**File #:** Res 0222-2014      **Version:** \*      **Name:** LU 47 - Zoning, Special Hudson Yards District, Manhattan (N 140191 ZRM)  
**Type:** Resolution      **Status:** Adopted  
**In control:** Committee on Land Use

THE COUNCIL OF THE CITY OF NEW YORK  
RESOLUTION NO. 222

Resolution approving the decision of the City Planning Commission on Application No. N 140191 ZRM, for an amendment of the Zoning Resolution of the City of New York, concerning Article IX, Chapter 3 (Special Hudson Yards District) in Community District 4, Borough of Manhattan (L.U. No. 47).

**Chapter 3: Special Hudson Yards District**

Map 1 - Subdistrict B: 450 West 33<sup>rd</sup> Street and Ninth Avenue Rail Yard Public Access Area Plan

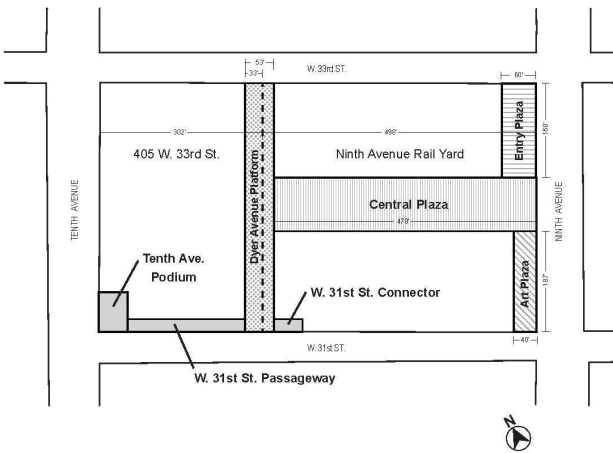
A permanent easement shall be provided along the eastern edge of 450 West 33<sup>rd</sup> Street, as shown on Map 1 (Subdistrict B: 450 West 33<sup>rd</sup> Street and Ninth Avenue Rail Yard Public Access Area Plan) in Appendix B of this Chapter, for the purposes of constructing the Dyer Avenue platform required pursuant to paragraph (d) of Section 93-73 (Public Access Areas on Ninth Avenue Rail Yard). Such easement shall have a minimum width of 33 feet. Any amenities required by paragraph (d) of Section 93-73 may be located within such easement.
